Access Compliance Report

Public Rights-of-Way

Intersection ID: 29229	Main Street: KORNIV_DR	Cross Street: LAUREN_KAY_CT	Location: NE
ADA ID: B8E8F958CE07	Ramp Type: PerpDiag	Initial Pass/Fail: Pass	Overall Compliance: No
			Severity Score: 25.25

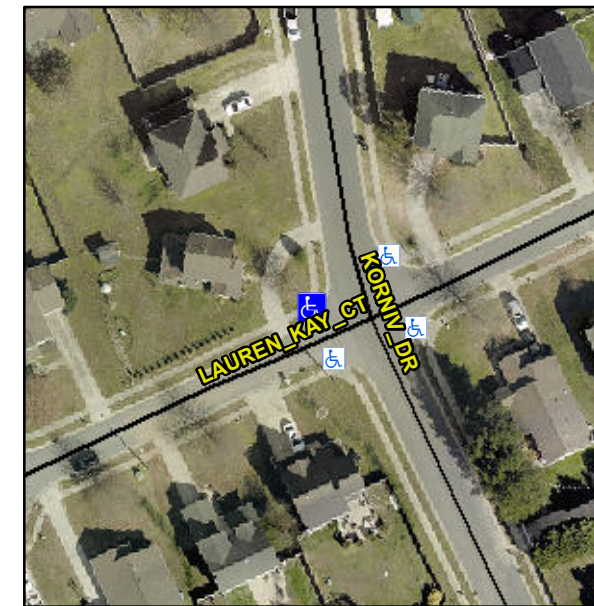
Not Found, R304.5.3, R304.2.1, R304.2.2-Perp, R304.3.2-Para, R305.1.4, R305.2, R302.7.2, R304.5.4

Compliance	Description	Data	Compliance	Description	Data
N/A	Ramp Length (in)	86.0	Yes	Ramp Slope (%)	5.5
Yes	Ramp Width (in)	56.0	No	Ramp XSlope (%)	3.0
N/A	Flare Type LT	Sloped	N/A	Flare Type RT	N/A
N/A	Flare Slope LT (%)	3.2	Yes	Flare Slope RT (%)	6.9
N/A	Flare Traversable LT?	Yes	N/A	Flare Traversable RT?	Yes
No	Landing Length (in)	N/A	Yes	DWS Provided?	Yes
No	Landing Width (in)	N/A	Yes	DWS Contrast?	Yes
No	Landing Slope (%)	N/A	Yes	DWS Length (in)	25.5
No	Landing X Slope (%)	N/A	No	DWS Full Width?	No
N/A	Landing Curb? (Y/N)	No	No	DWS Offset (in)	3.5
N/A	Shared Landing?	No			
Yes	Gutter Ponding?	No	No	Gutter Slope (%)	10.0
No	Gutter Lip Ht (in)	0.5	Yes	Gutter X Slope (%)	1.4
N/A	Painted X Walk1?	No	N/A	Painted X Walk2?	No
	X Walk 1 Direction	To W		X Walk 2 Direction	To S
N/A	X Walk 1 Width (in)	N/A	N/A	X Walk 2 Width (in)	N/A
	X Walk 1 Slope (%)	3.4		X Walk 2 Slope (%)	0.8
	X Walk 1 X Slope (%)	2.4		X Walk 2 X Slope (%)	1.2

Remove & Replace Curb Ramp With Two New Directional Ramps or Equivalent. Remove & Replace Gutter.
